PLANNING BOARD MEETING

1. Site Plan & Design Review - Short Street

9 SHORT STREET
REAR YARD MODIFICATION
RANDOLPH, MASSACHUSETTS

STAFF REPORT

PROPOSED RENDERING

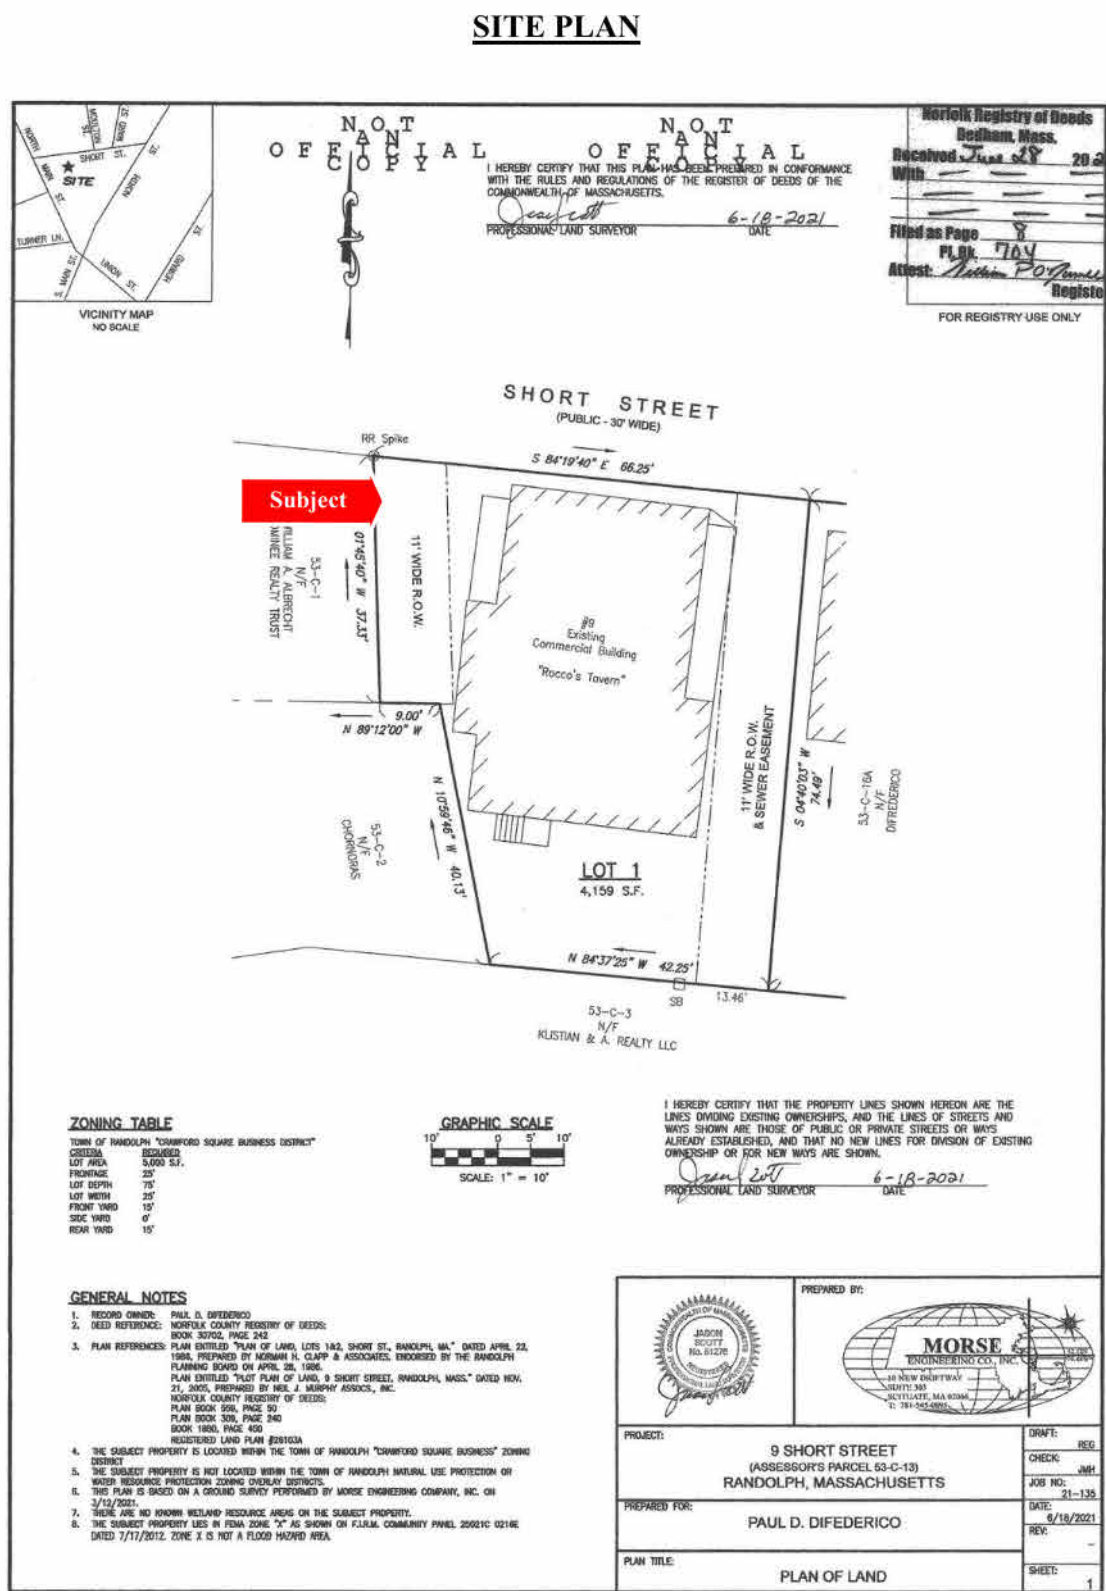
- a. Pictorial renderings (page 4) depict a new door on the eastern side of the structure but there is no corresponding reference on the civil plans A-101). Either the civil plan or the pictorial renderings submitted should be correct to accurately indicate the intent.
- b. The plan set (A-101) indicated concrete sloping to a “private way”. There is no private way associated with the parcel. Plan notes should be corrected.
- c. The plan set (A-101) indicates the fencing is vinyl coated fence but the narrative with spec sheets calls out a fence panel. Either the civil plan or the pictorial renderings submitted should be correct to accurately indicate the intent.
- d. The plan set (A-101) calls out a drain at the landing but no plan set includes the placement of a dry well.
- e. The plans do not call out roof drains and how the run-off will be managed.

EXISTING PLOT
PLAN &
CERTIFIED PLOT
PLAN

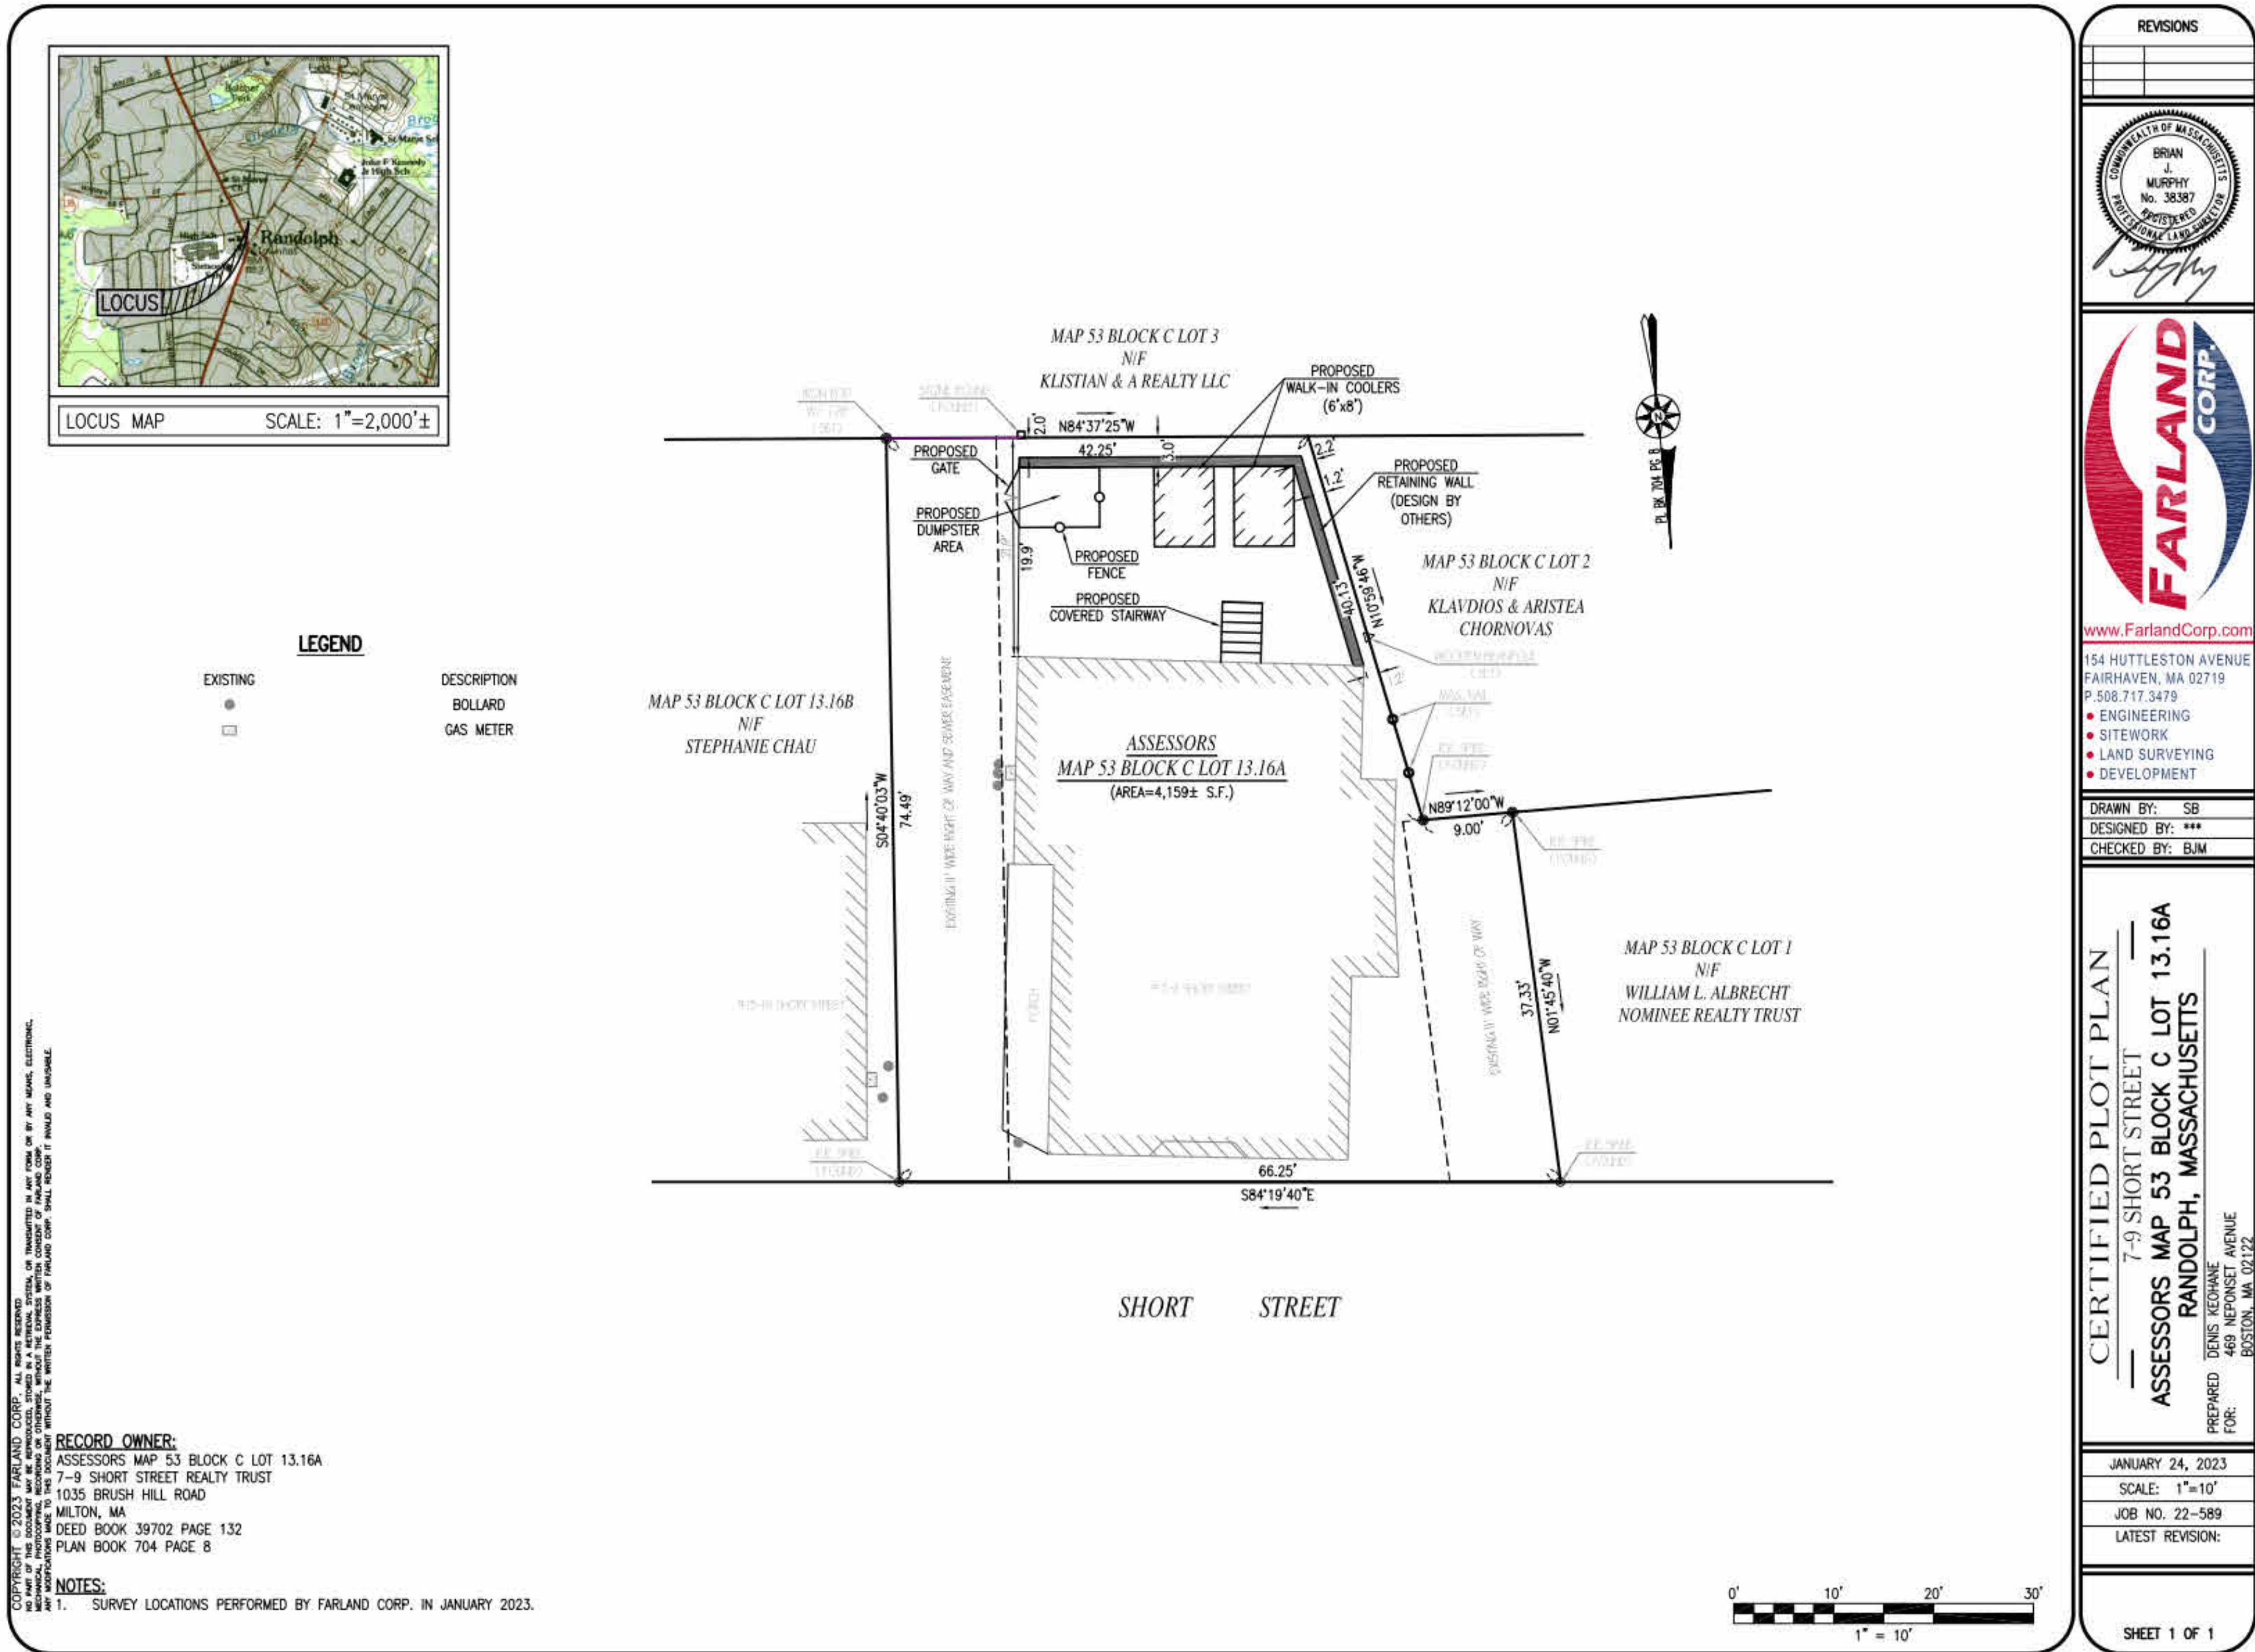
- Application for Tier 2 review
- Existing plot plan and certified plot plan prepared by Farland Corp dated January 2023
- Site Plan Set prepared by Spaulding Tougias Architects, Inc. dated October 19, 2023
- Narrative summary with spec sheets (undated, preparer unknown)
